**Evaluation of Draft Environmental Impact Report on
Geological Storage of Carbon Dioxide at the Carbon
TerraVault I Facility in Kern County, California**

Dominic DiGiulio, Ph.D.

**Independent Consultant for the Environmental Integrity Project's
Center for Applied Environmental Science**

February 25, 2024

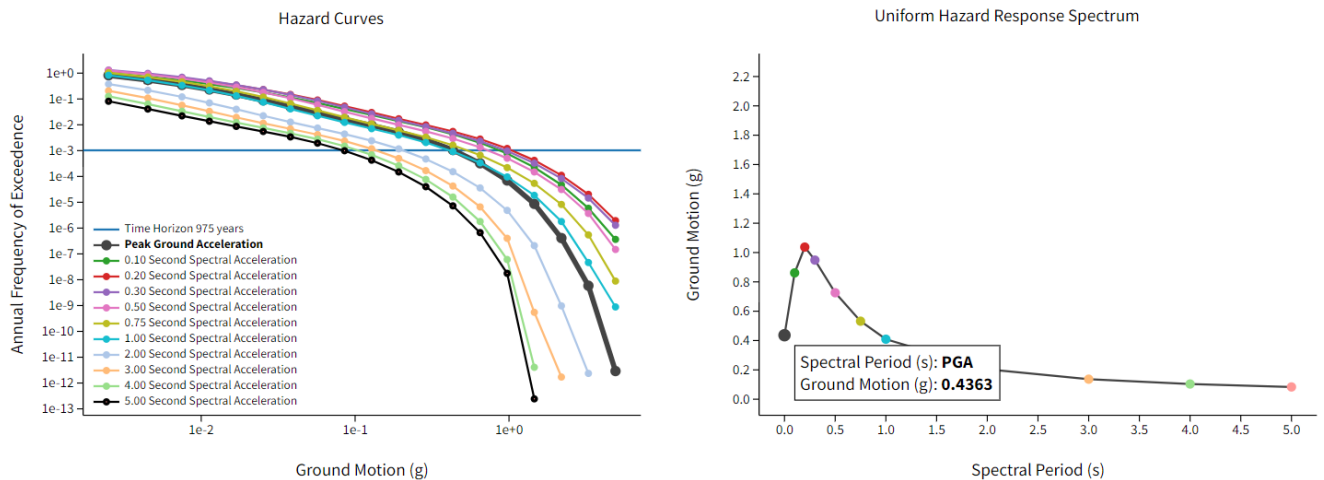
For the project location, a peak ground acceleration rate of 0.4363g was estimated having a 5% probability of exceedance in 50 years with an annual rate of exceedance = 1.025E-03 or a return period of 475 years (DEIR, 2024b). The return period or time horizon is the inverse of the annual rate of

exceedance. Using the USGS “rule of thumb” for calculating return period, this is approximately equivalent to a 9.8% probability of exceedance in 100 years, a 42% probability of exceedance in 500 years, and a 69% probability of exceedance in 900 years. A further examination of the hazard curves (Figure 5) (not included in the DEIR) indicates a peak ground acceleration of 0.3175g having a 10% probability of exceedance in 50 years, 19% probability in 100 years and a 64% probability of exceedance in 400 years. Care was taken in these calculations to ensure that $r^* \leq 1$ where $r^* = r(1+0.5r)$ and $r =$ probability as recommended by USGS (USGS, 2024).

These regulations do not address wellbore integrity, however. It is not clear whether wellbores can withstand a peak ground acceleration of 0.258g, let alone peak ground accelerations of 0.3175g or 0.4363g. A peak ground acceleration of 0.27 g is associated with a Modified Mercalli Intensity of VIII with observations including: steering of motor cars affected; damage to masonry and some masonry walls; twisting, fall of chimneys, factory stacks, monuments, towers, elevated tanks; frame houses moved on foundations if not bolted down; loose panel walls thrown out; changes in flow or temperature of springs and wells; and cracks in wet ground and on steep slopes. Hence, this mitigation measure is not appropriate, at least for wellbores like those that would be impacted at Elk Hills. Also, Templeton et al. (2021) state that an evaluation of the anticipated losses as a function of ground motion intensity can be achieved either directly by using vulnerability functions or indirectly through the use of fragility functions. Vulnerability functions directly relate ground motion intensity to anticipated losses. Fragility functions relate ground motion intensity to the probability of damage and are often expressed as either loss ratio curves, damage probability matrices, or fragility curves (Templeton et al., 2021). There does not appear to be vulnerability and fragility functions associated with oil and gas wellbores. However, based on a Modified Mercalli Intensity of at least VIII, wellbore damage would reasonably be expected from a major seismic event within 100 km of the Carbon TerraVault I project. The Level of Significance for Impact 4.7-2 should be changed from Less than Significant to Significant and Unavoidable. In the presence of moderate seismic activity at the project area (e.g., $MMI \geq 5$, $PGA \geq 0.05g$, $PGV \geq 3.0$ cm/s), mitigation should include assessment of leakage at wellbores and reentry and replugging of wellbores in the event of increased leakage from wellbores.

Figure 6. Schematic representation of pressure migration along a high-permeability fault between the Tejon Oil Field and a M 4.6 seismic event along the White Wolf Fault.

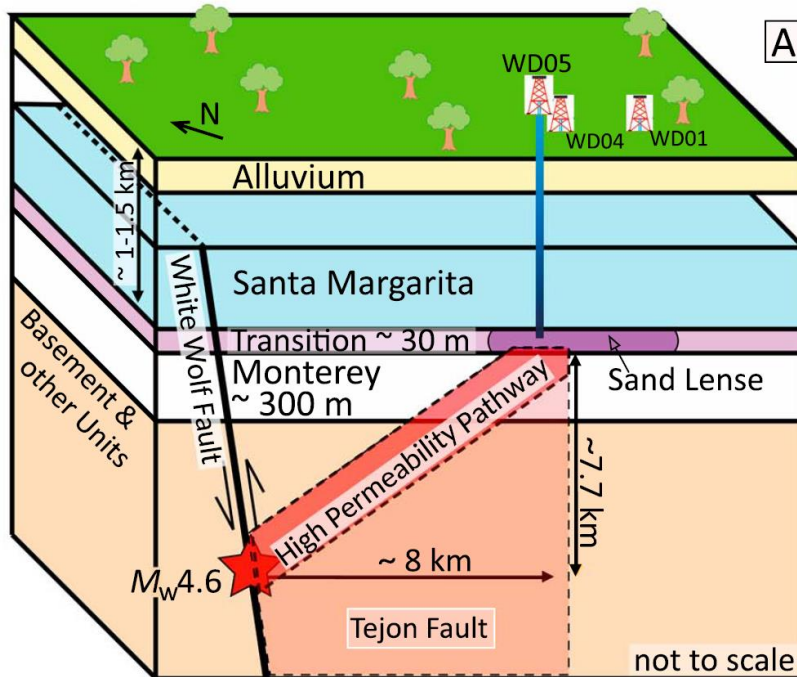
Comment: For induced seismicity, the primary concern here is pressure transmission below the Monterey Formation, not above it. In the Class VI regulations, the primary concern is leakage through faults in the confining layer, not transmission of pressure and induced seismicity below the storage formation. Hence, neither EPA regulations nor the DEIR adequately consider induced seismicity. Callas et al. (2022) state that lack of a lower confining seal (permeability > 100 nD) (nD = nanodarcy) is a disqualifying threshold for geologic storage of CO₂ because of potential pressure propagation to basement rock capable of producing seismic activity. According to schematics provided in Volume 2 of the DEIR, the Reef Ridge Shale bounds both the upper lower Monterey Formation and has an average permeability of 0.01 mD (mD=millidarcy) or 10,000 nD. As discussed, in the 26R and A1 - A2 Storage Areas, CTV states that final pressure will target the initial reservoir pressure at the time of discovery. Hence, this would decrease but not eliminate the possibility of induced seismicity.
